Final Environmental Impact  
Report for Hyperion Treatment  
Plant Digester Gas Utilization  
Project:  
Power and Steam Generation

Prepared for:  
**City of Los Angeles**  
Los Angeles, California

Date:  
**August 2013**  
**Revised October 2013**

Figure 2-3a. Process Flow Diagram

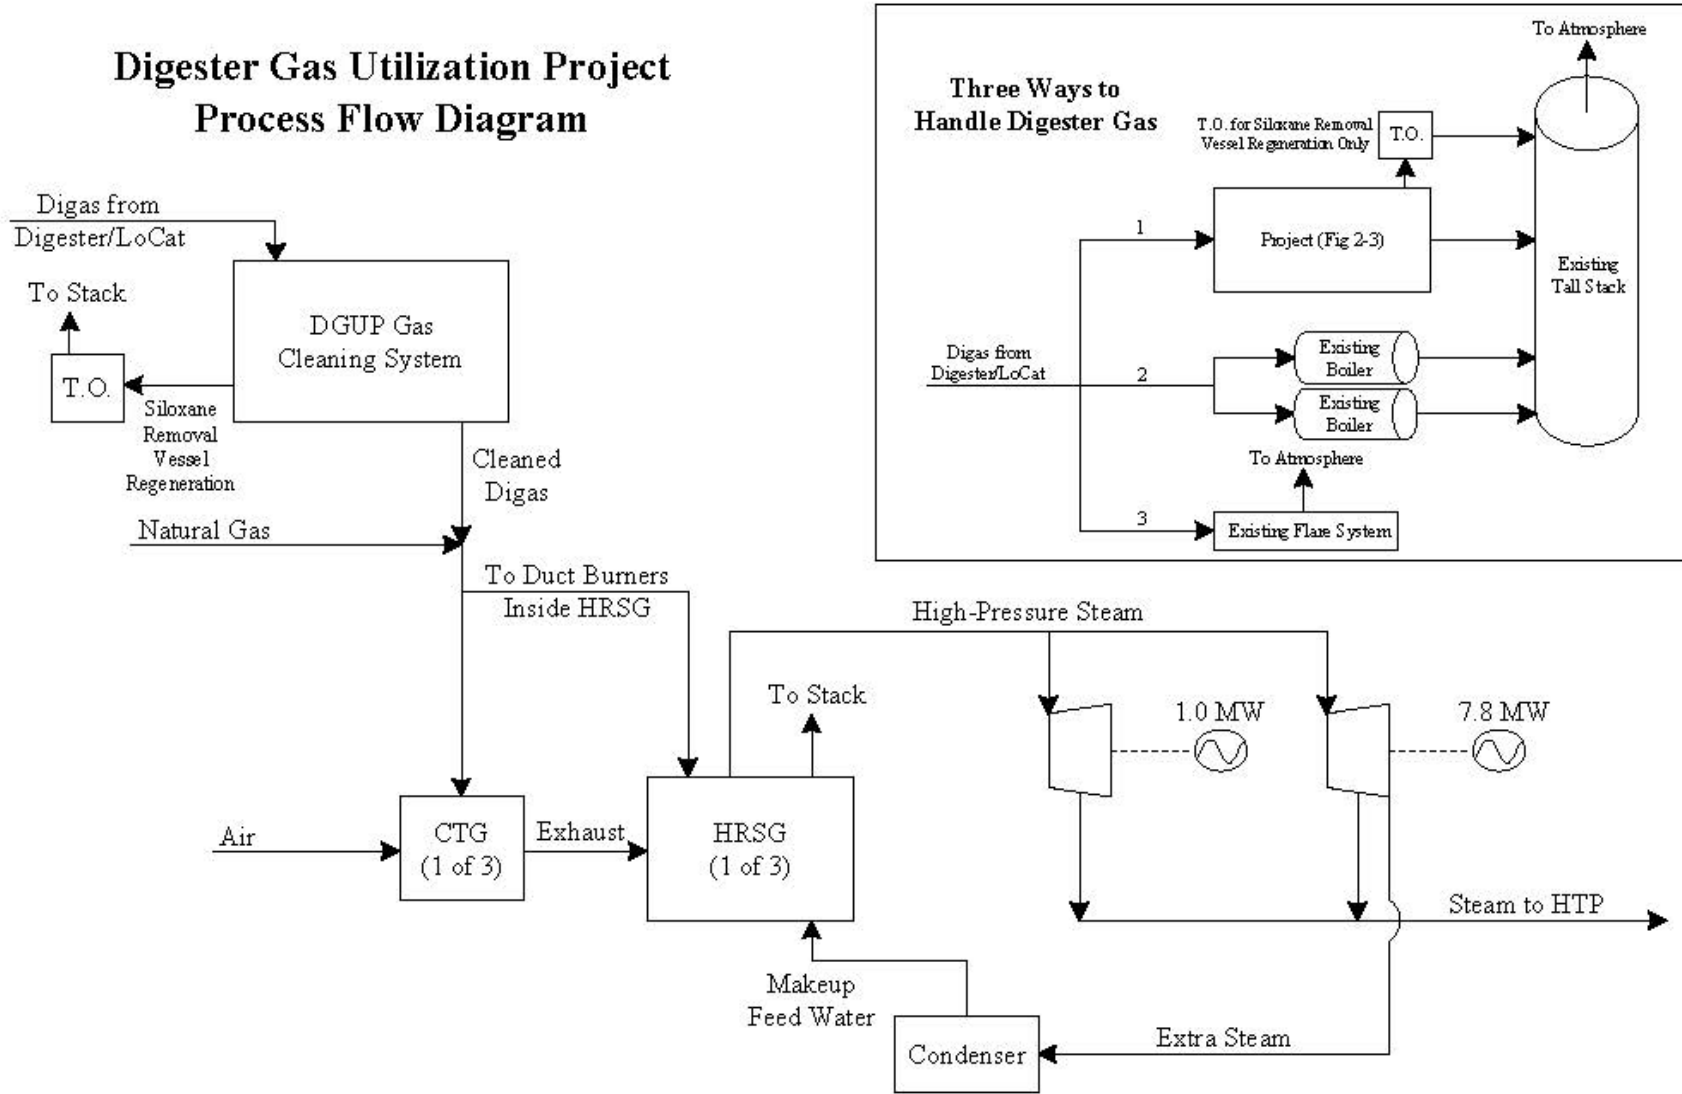
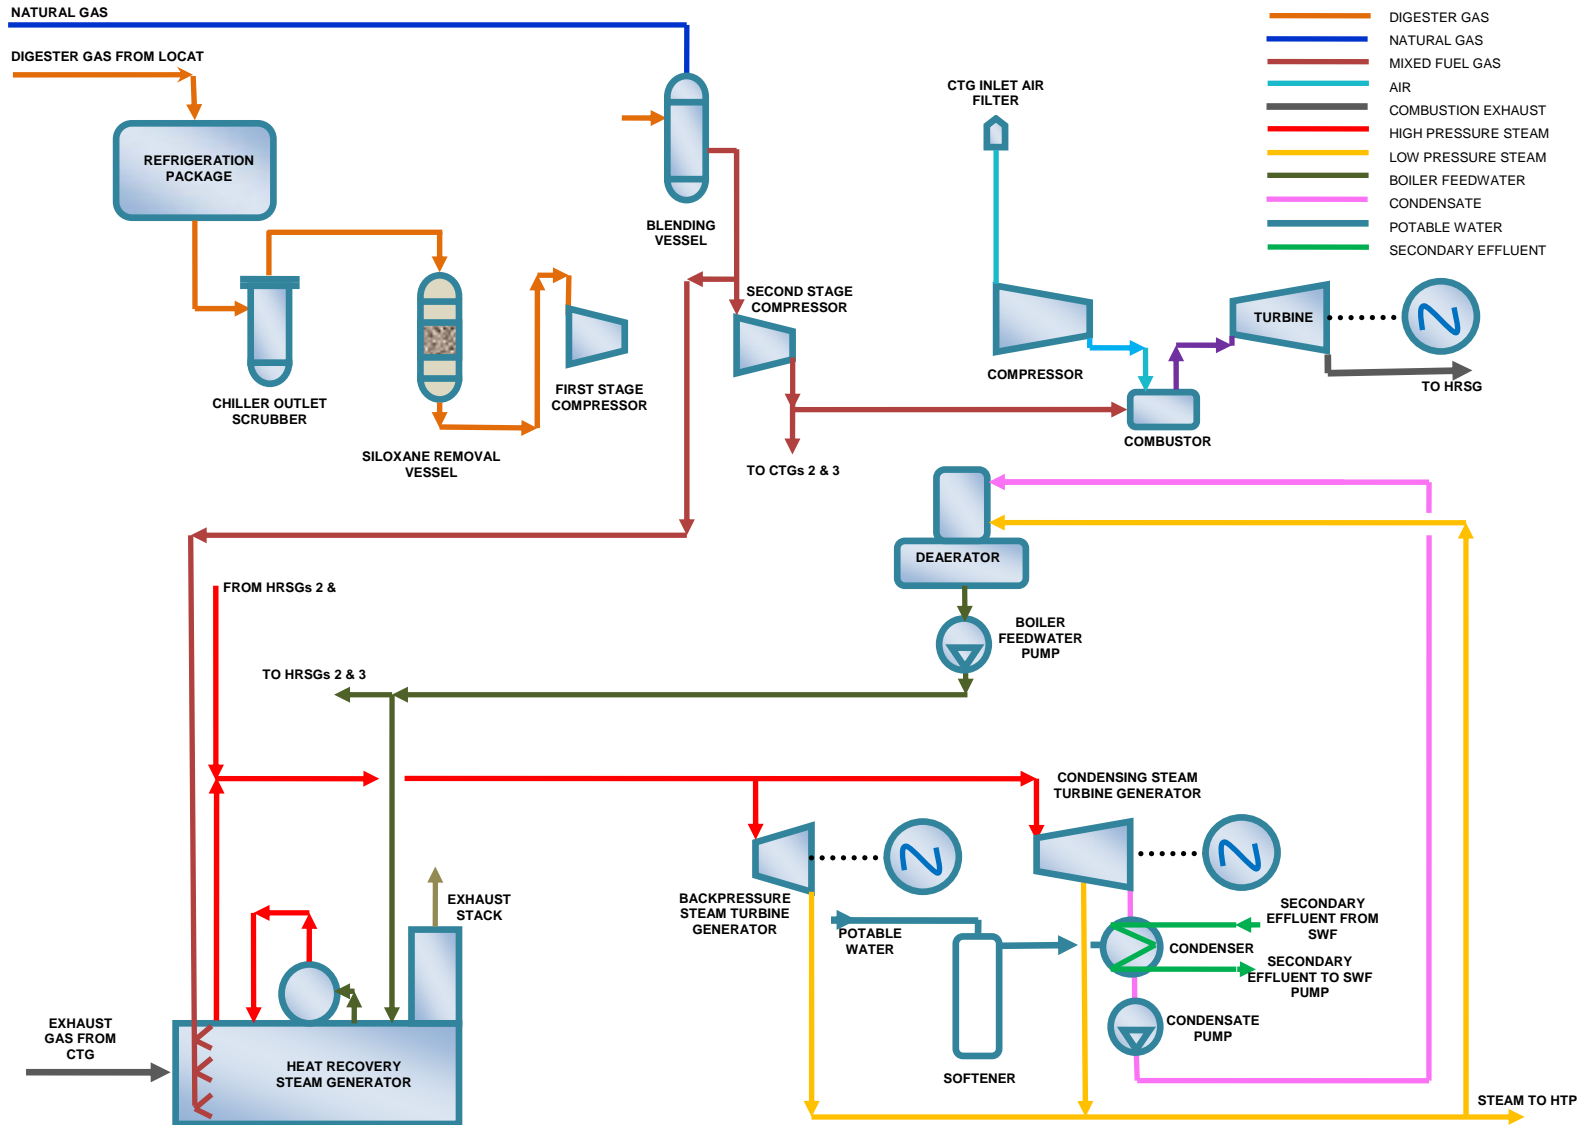
Therefore, SCAQMD staff recommends that the lead agency revise the project description to more fully reflect all equipment that will operate if the proposed project is built. Also, the lead agency should either revise Figure 2-3 (Process Flow Diagram) of the Draft EIR or provide a new flow chart that includes all equipment (existing and new) as well as emission sources from the proposed project.

There may have been some confusion in the analysis of the modeling files, which also list other non-project equipment. The City has discussed with SCAQMD staff the modeling analysis (including the baseline case) and related assessment to clarify the equipment included in the different scenarios (e.g., baseline, project, etc.). The permit applications and the proposed project do not have the same equipment lists. Emissions from other non-project sources are not related to gas handling or utilization; their emissions are constant over the time frame of the project. As such, the City believes that it is not necessary (and possibly confusing) to include multiple equipment lists. See Response 3-0B for additional information.

- Section 2.5, after page 10. Add Figure 2-3a (see figure below) on page 11a.
- Section 2.5, after page 11a (preceding bullet). Rename Figure 2-3 (Draft EIR) as Figure 2.3b on page 11b.
